## BOARD OF ZONING APPEAL

### BZA Application Form

**BZA Number: 162489**

**LOCATION OF PROPERTY:** 1 Longfellow Rd., Cambridge, MA

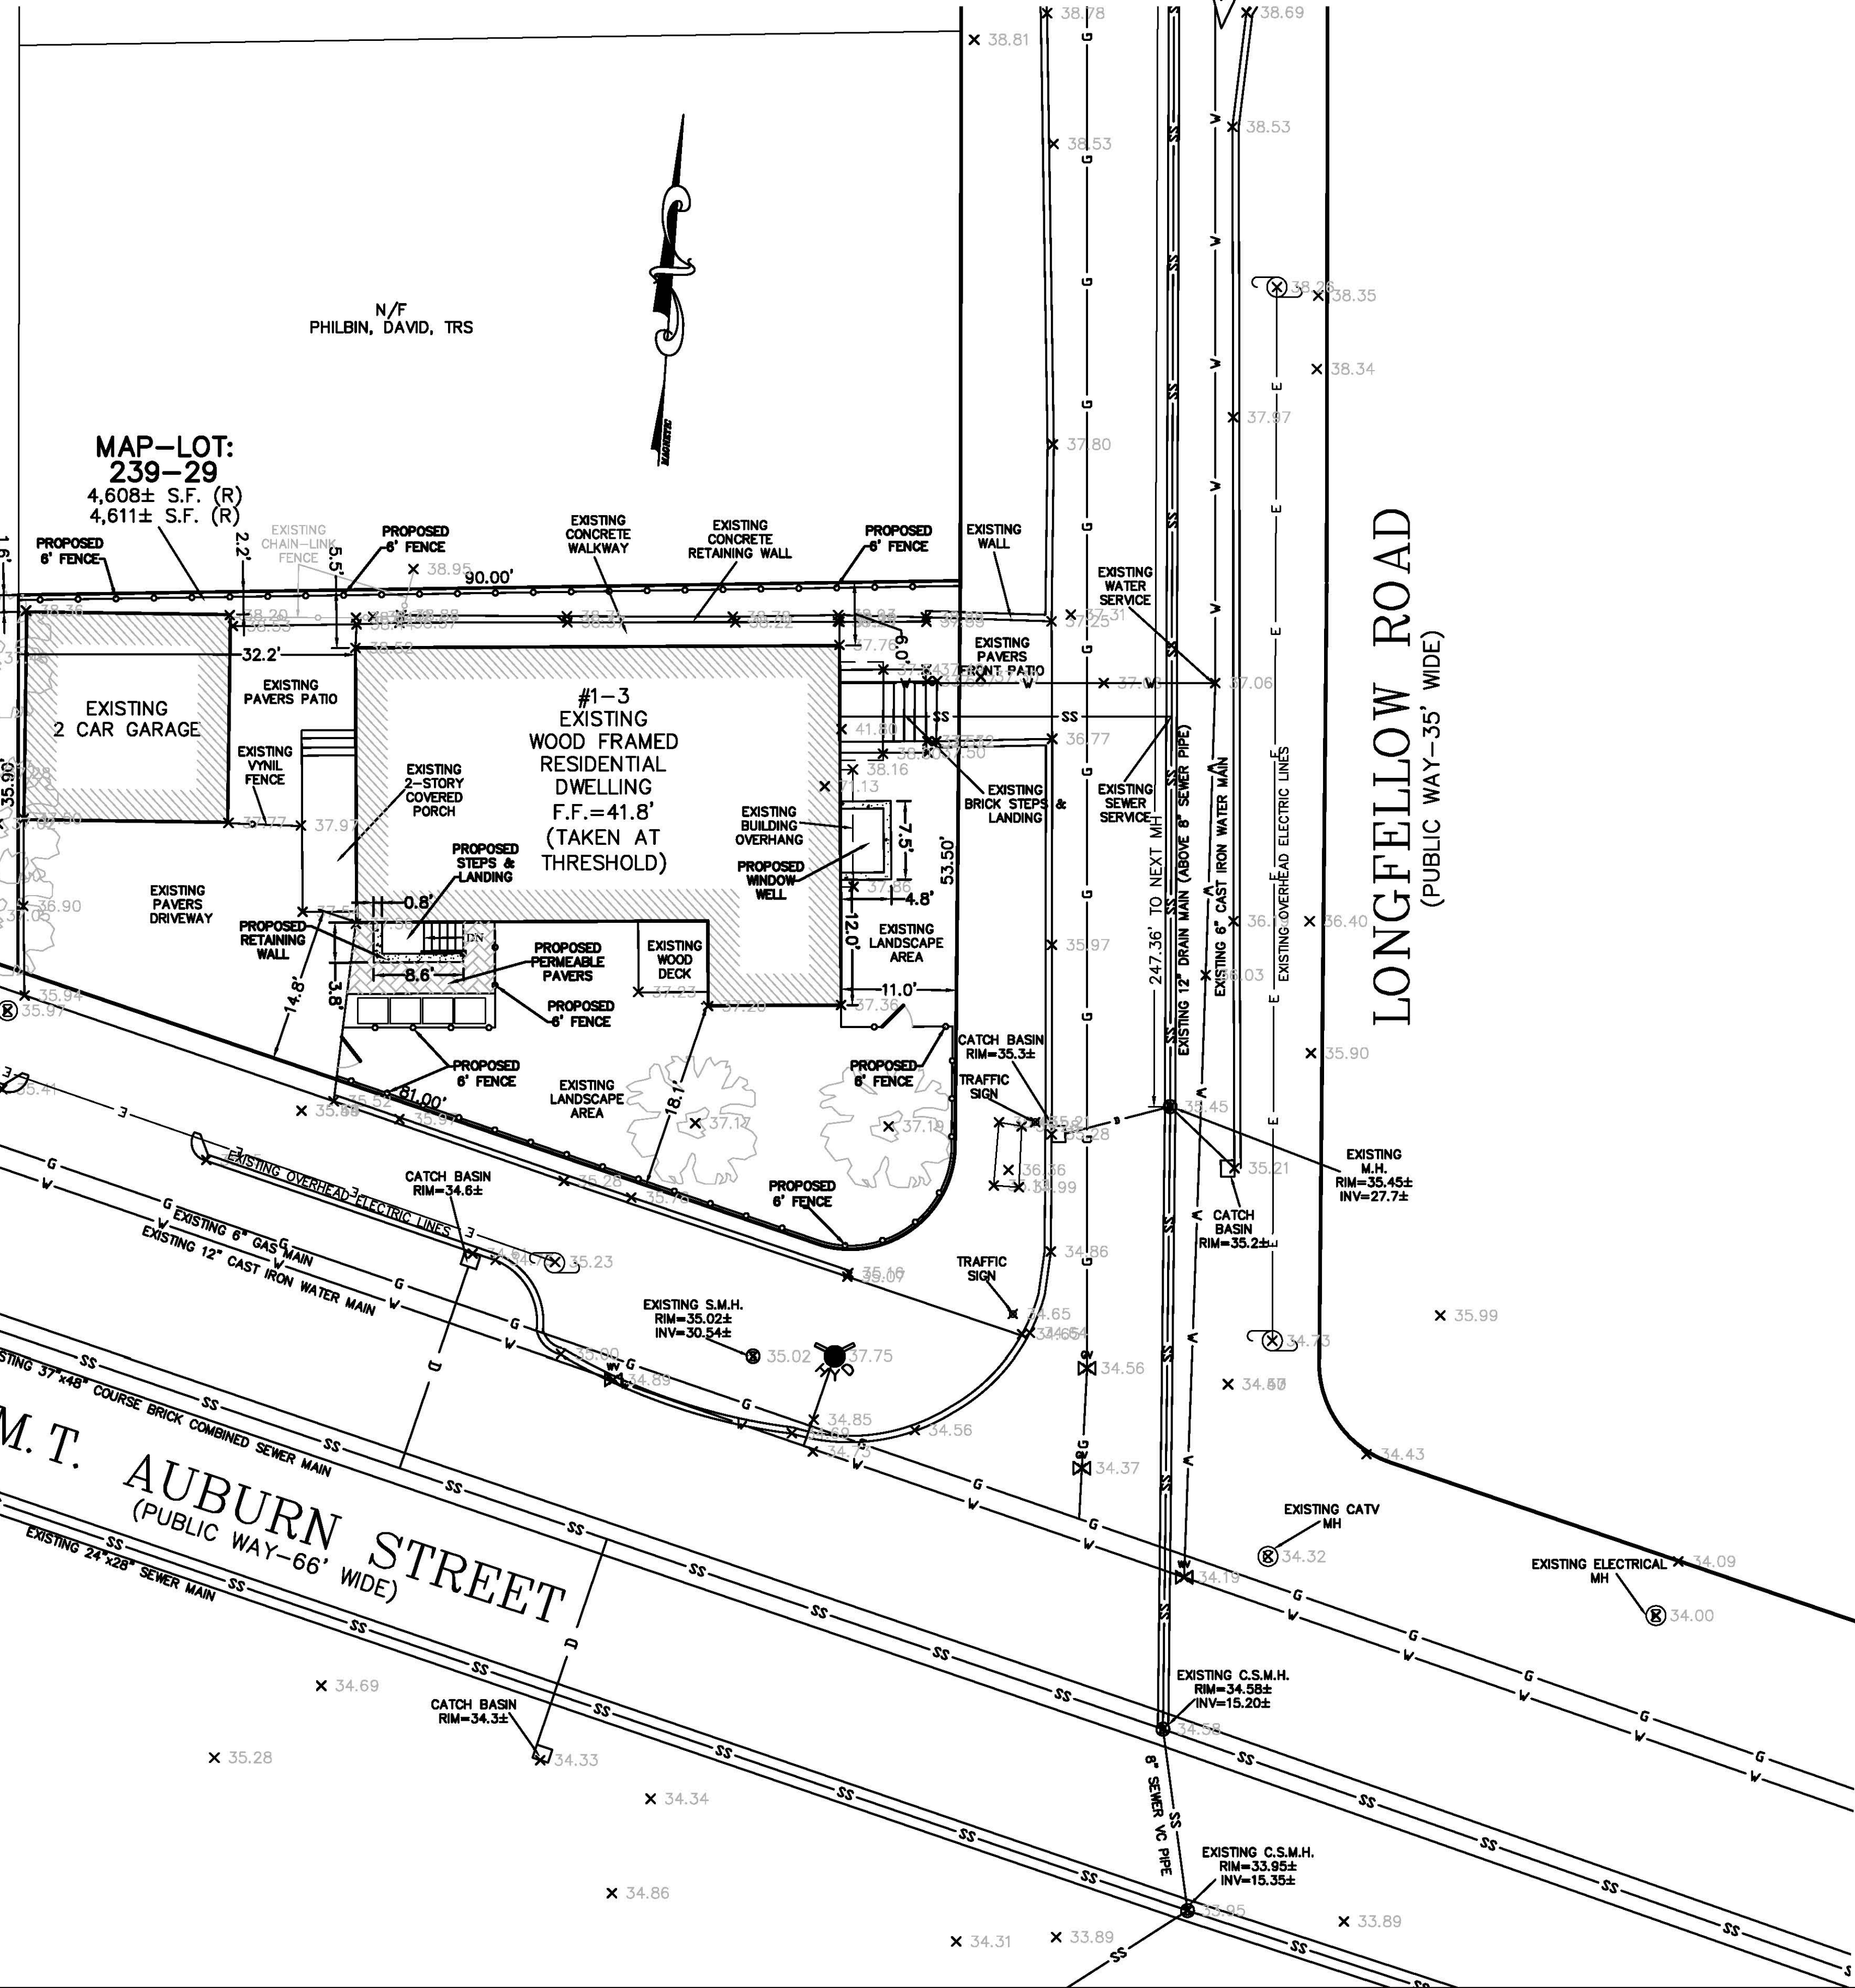
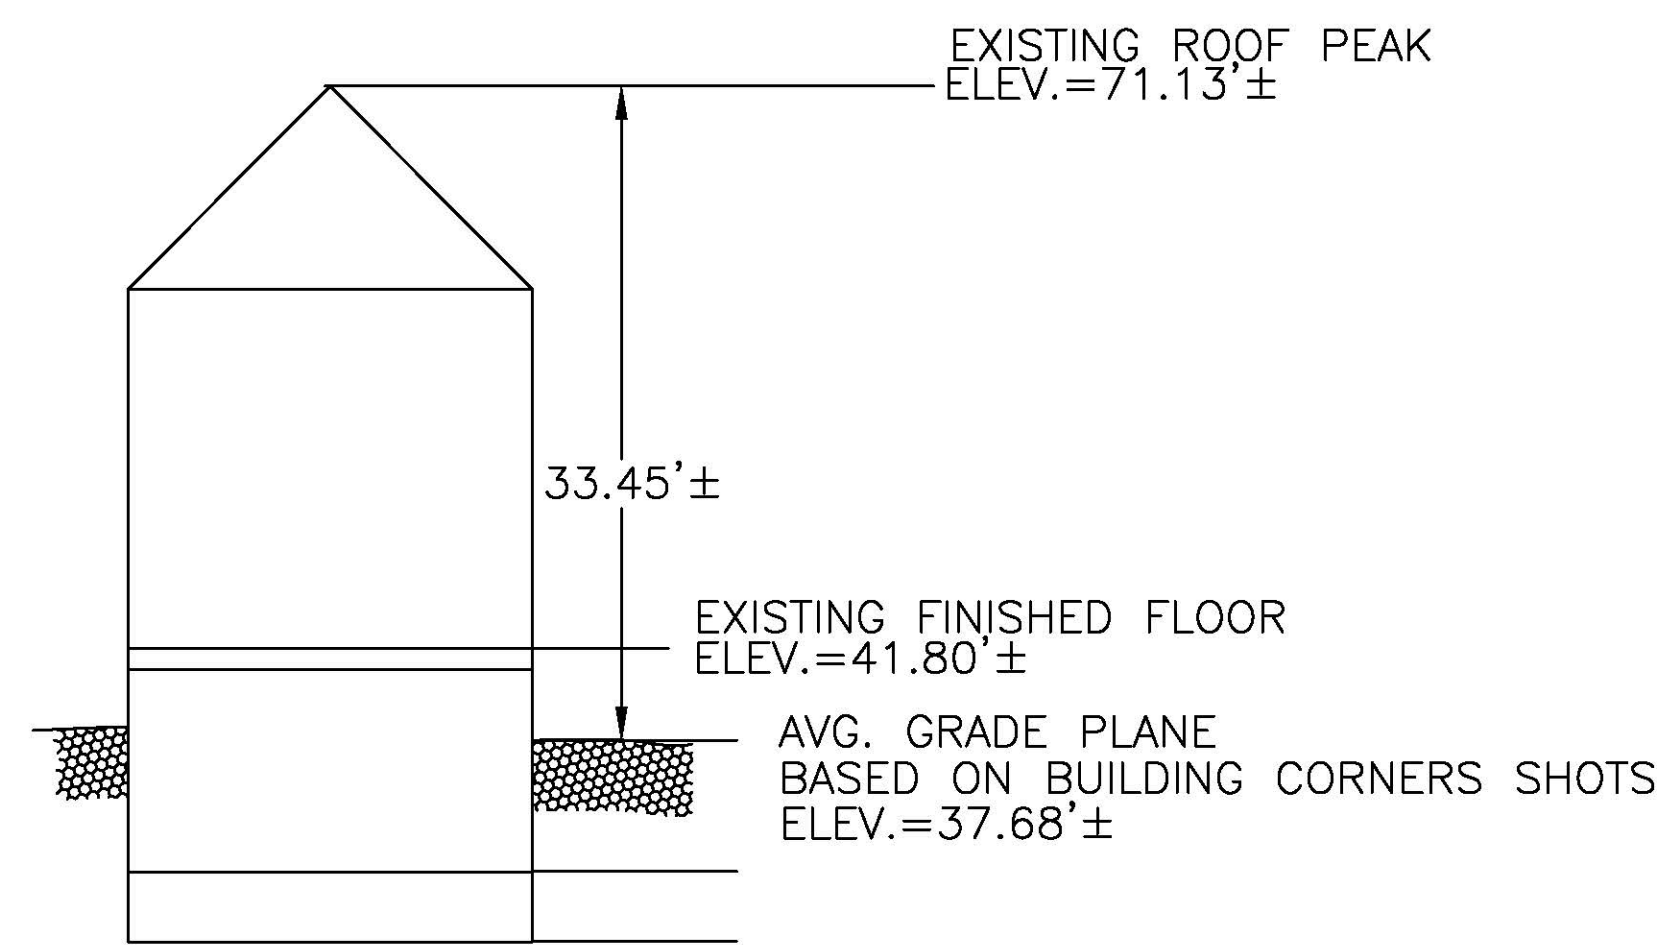
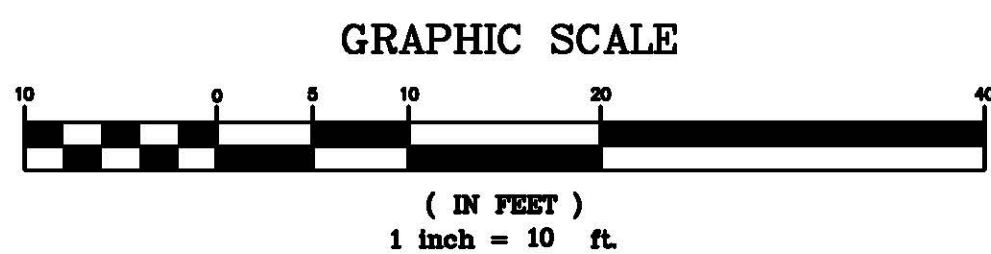
–The updated 4/6/22 Proposed Site Plan by Peter Nolan (originally dated 3/25/21) shows the existing curb but does not show the 2 new window wells. However, it does show a proposed 6-foot high fence along the entire property from the street to the back property line located within the (disputed) Hester property.

—The updated 4/6/22 Proposed Site Plan by Peter Nolan (originally dated 3/25/21) shows the existing curb but does not show the 2 new window wells. However, it does show a proposed 6-foot high fence along the entire property from the street to the back property line located within the (disputed) Hester property.

5 EXTERIOR WALKWAY/WALL DETAIL  
1/2" = 1'-0"

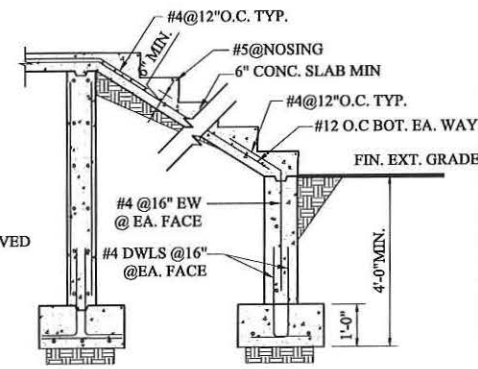
in his email of 4/5) and egress windows and lowered new sidewalk. The plan does not show the new walkway/wall that is shown in detail 5 on drawing A-901. This walkway/wall is located in (disputed) Hester property.

—The 4/5/22 SKA Architect Building set shows the following on the Hester side: 2 new window wells (not showing grates over the sidewalk as stated in his email of 4/5) and egress windows and lowered new sidewalk. The plan does not show the new walkway/wall that is shown in detail 5 on drawing A-901. This walkway/wall is located in (disputed) Hester property.
